Public Meeting on Oklo Topical Reports

September 1, 2021

MCA and Performance-based Licensing Topical Reports

Maximum Credible Accident Topical Report

4.4 Classifying functions and features

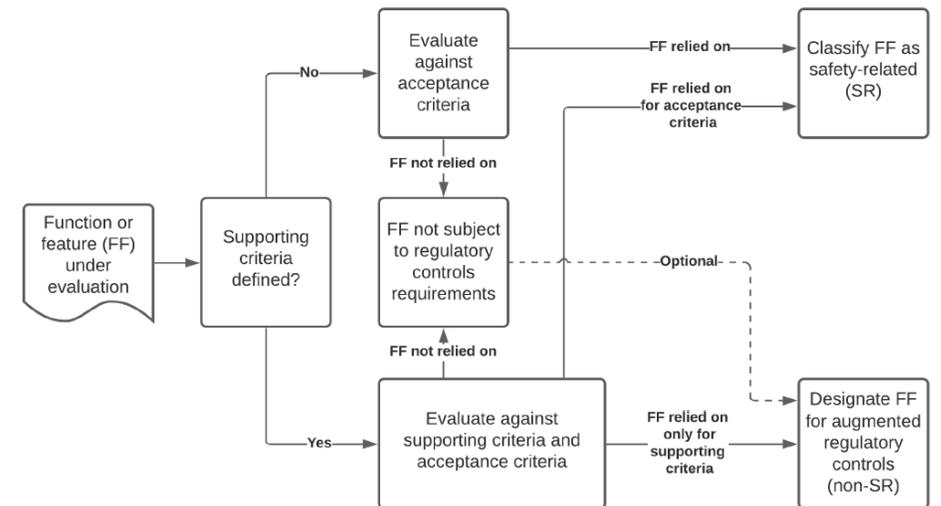
C. The PBLM TR does not address the regulatory requirement under 10 CFR 50.34(f)(3) that the application provide sufficient information to demonstrate that the quality assurance list required by Criterion II, Appendix B, 10 CFR Part 50 includes all structures, systems, and components (SSCs) important to safety.

- Section 4.4, provides for a systematic approach to classifying functions and features.

The methodology identifies the safety relevance of each function and feature of the design as it contributes to the licensing basis event analysis. To make this determination, each function and feature is evaluated individually to determine whether the function or feature is relied on to meet the acceptance criteria and supporting criteria (if defined). Figure 4-1 schematically shows the evaluation process for functions and features described in the following sections.
